**IN THE MATTER:** an application for approvals for the Lake Pūkaki Hydro Storage  
and Dam Resilience Works

**STATEMENT OF EVIDENCE OF MURRAY GRANT WEBBY ON BEHALF OF  
MERIDIAN ENERGY LIMITED**

**TEKAPO B POWER STATION TAILRACE WEIR AND ROCK CHUTE**

Dated: 15 April 2026

TEKAPO B PS TAILRACE WEIR		FOLDER: XXX/XXX	DISTRIBUTION: -
	CONDITION ASSESSMENT BAY 4		DRAWING: TEK-B\TW\CHT\BAY-4	
	PLAN - 4 OF 4		COMPANY: DAMWATCH	
			NUMBER: E2621	ISSUE: R0

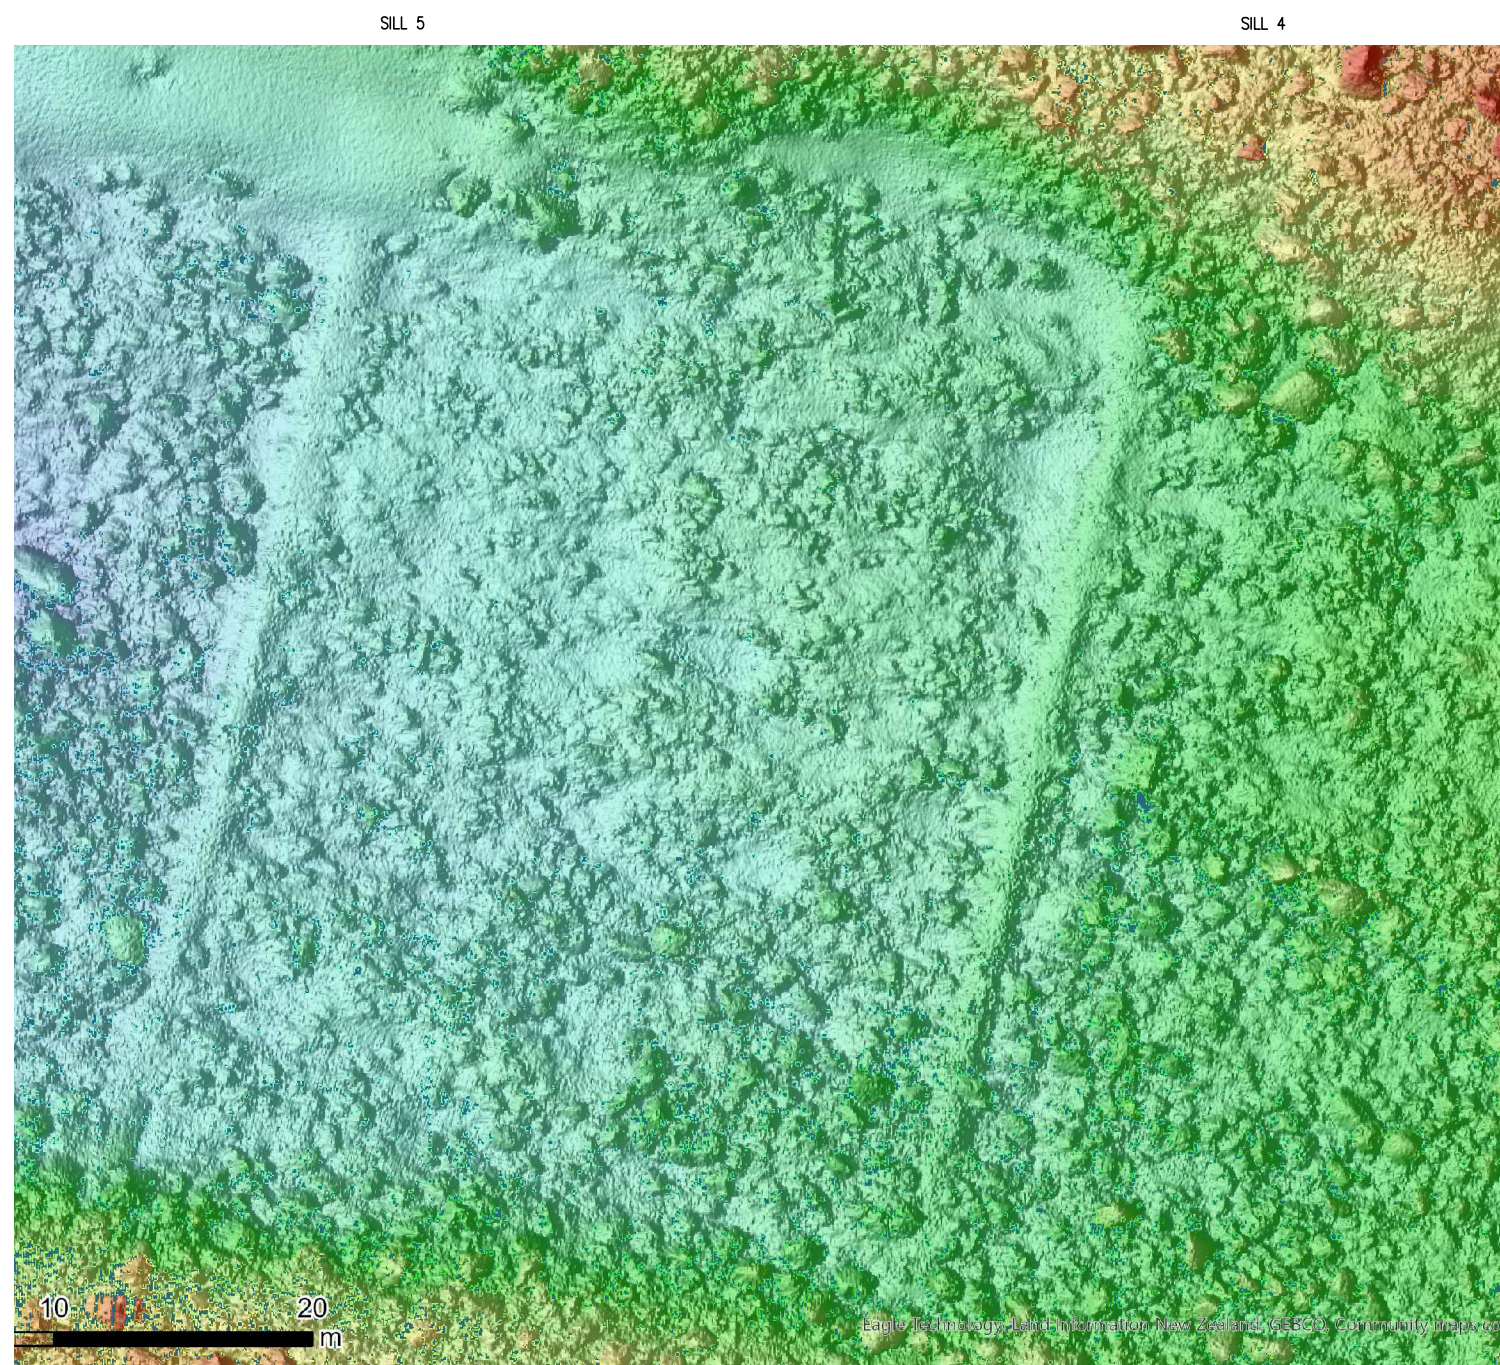
- 20 The depression apparent from the WSP bathymetric survey does not show up in the longitudinal centreline profile of the chute on the Damwatch Drawing TEK-B\TW\CHT\PROFILE SECTION in Appendix C of Damwatch document c (Paragraph 10). However, a dip in the longitudinal right side profile in the same drawing does show up immediately downstream of sill 4. A clear patch also shows up in the same location in the bathymetric survey image of bay 4 between sills 4 and 5 on **Drawing TEK-B\TW\CHT\BAY-4** in **Appendix A**.

- 21 Meridian plan to shortly undertake another dive inspection of the weir and chute structure when conditions allow to investigate these and other anomalies identified from the bathymetric survey imagery. Note that there are some lighter patches on the survey images of bay 3 and bay 4 on paper copies of **Drawings TEK-B\TW\CHT\BAY-3 and BAY-4** in **Appendix A** which appear to indicate an absence of boulders in the tightly packed mosaic of the rock lining. However, when viewed on a digital version of these drawings, it is possible to distinguish boulders within these patches. It may be that the boulders in these patches are masked to some extent by deposited sediment.

- 22 In the same planned dive inspection, Meridian have also instructed the divers to inspect sills 2, 3, 4 and 5 for any signs of damage or deformation due to foundation subsidence.

TEKAPO B PS TAILRACE WEIR		FOLDER: XXX/XXX	DISTRIBUTION: -
CONDITION ASSESSMENT LONG-SECTIONS		DRAWING: TEK-B\TW\CHT\PROFILE SECTION	
		COMPANY: DAMWATCH	
		NUMBER: E2621	ISSUE: R0

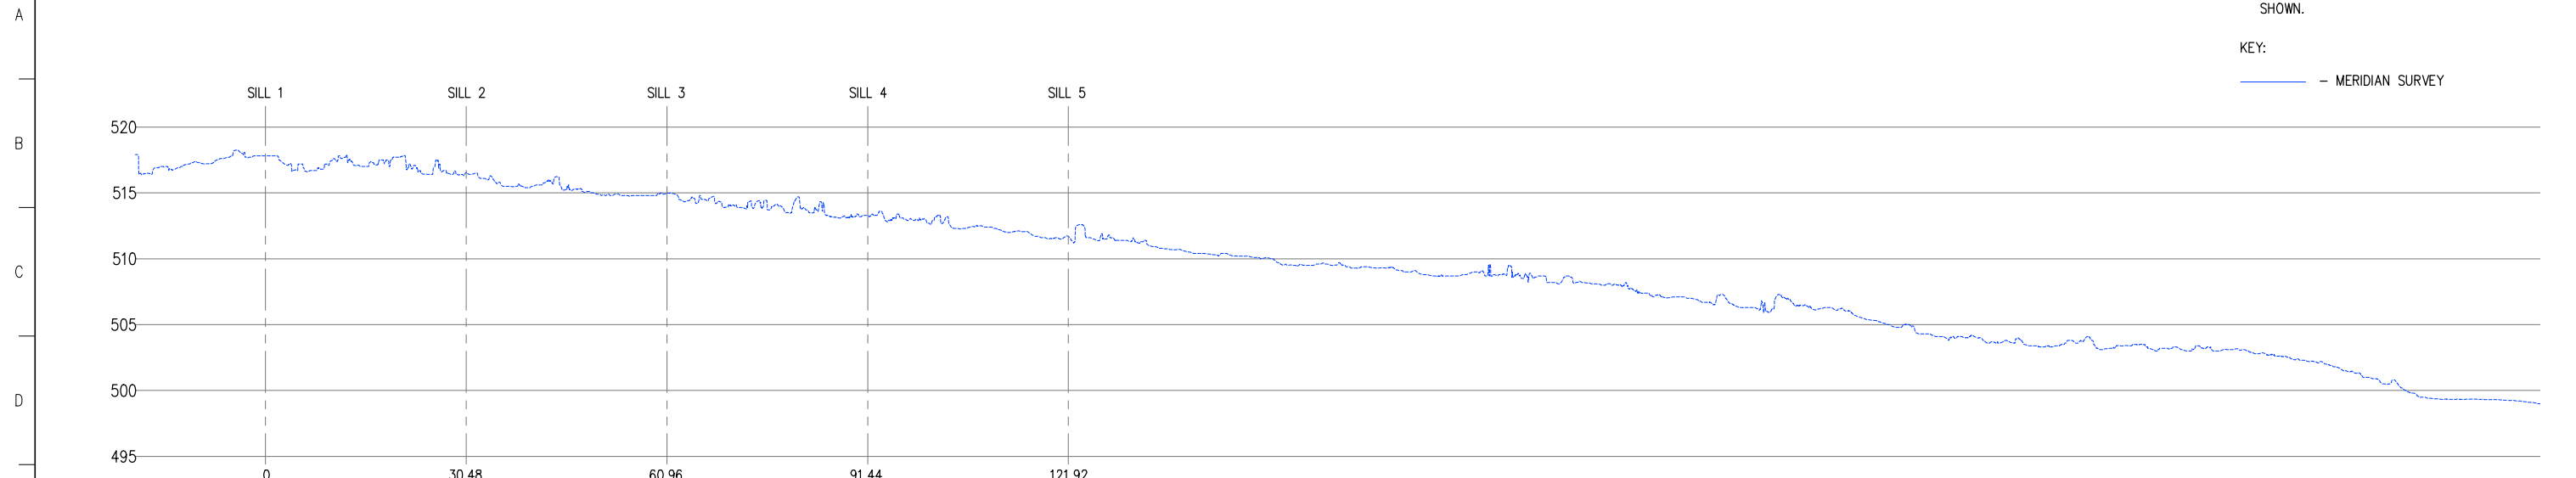
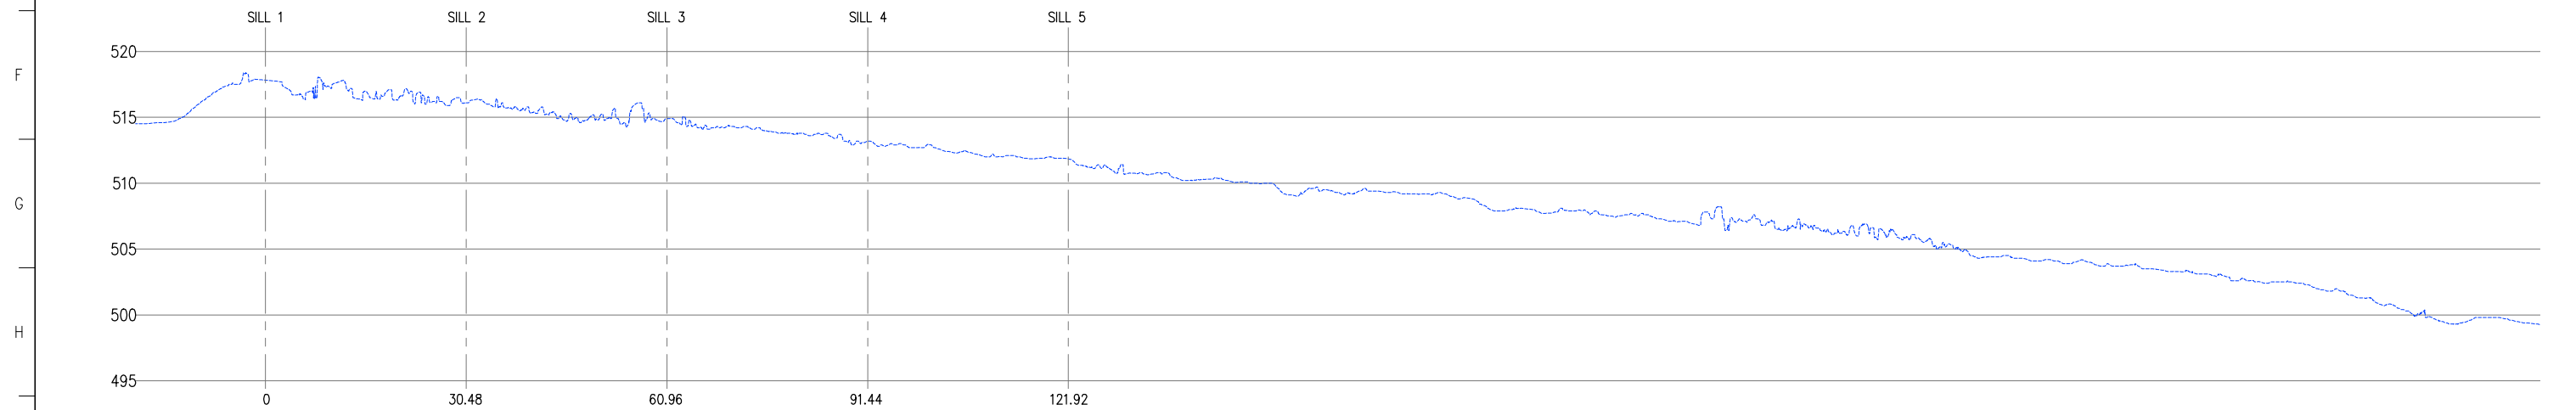
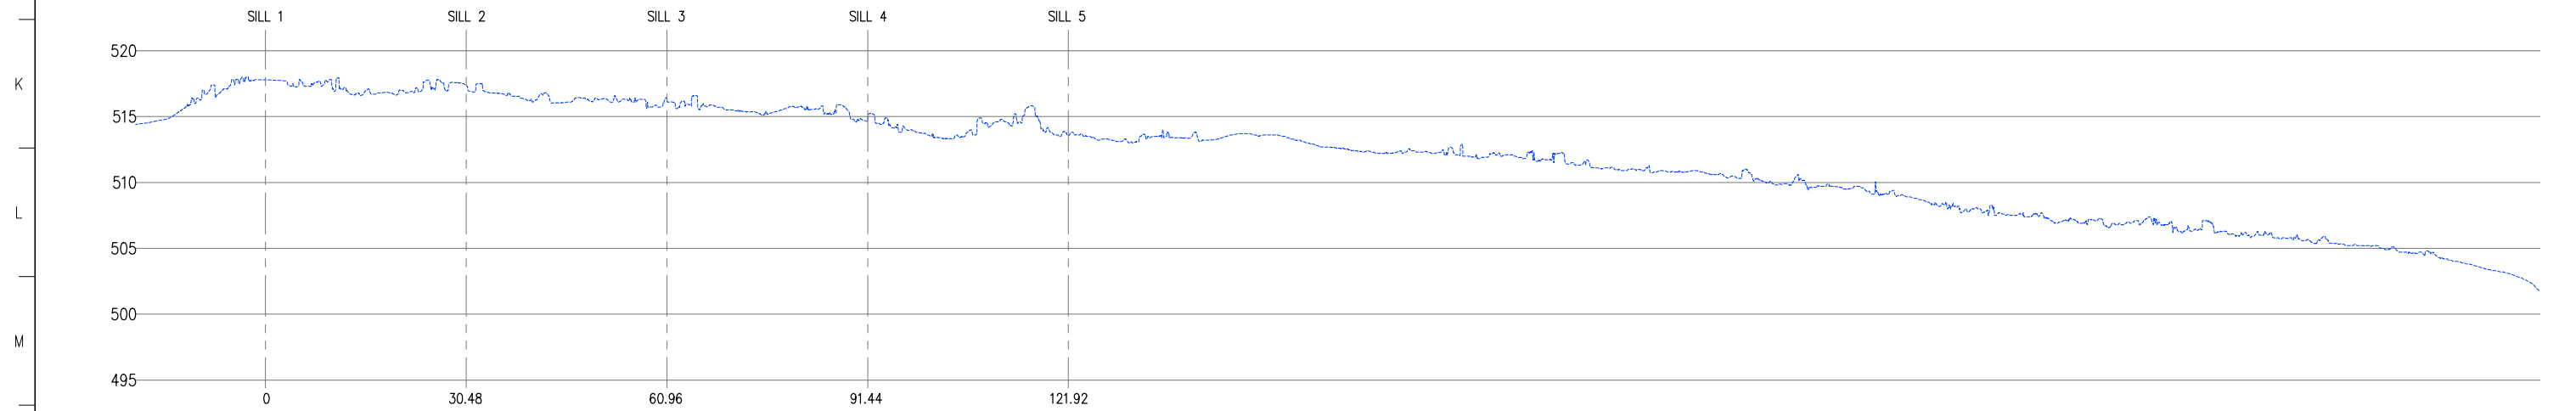
- 19 WSP in their document a (Paragraph 9) note that the longitudinal bed profile of the chute shown in Figure 3-5 (and sourced from their bathymetric survey) exhibits a 1 m drop below the mean bed slope at about distance 140 m from control weir sill 1. This would place this apparent depression in the rock lining between sills 4 and 5 (refer to the long-sections sourced from the separate bathymetric survey carried out for Meridian Energy on **Drawing TEK-B\TW\CHT\PROFILE SECTION** in **Appendix A**.
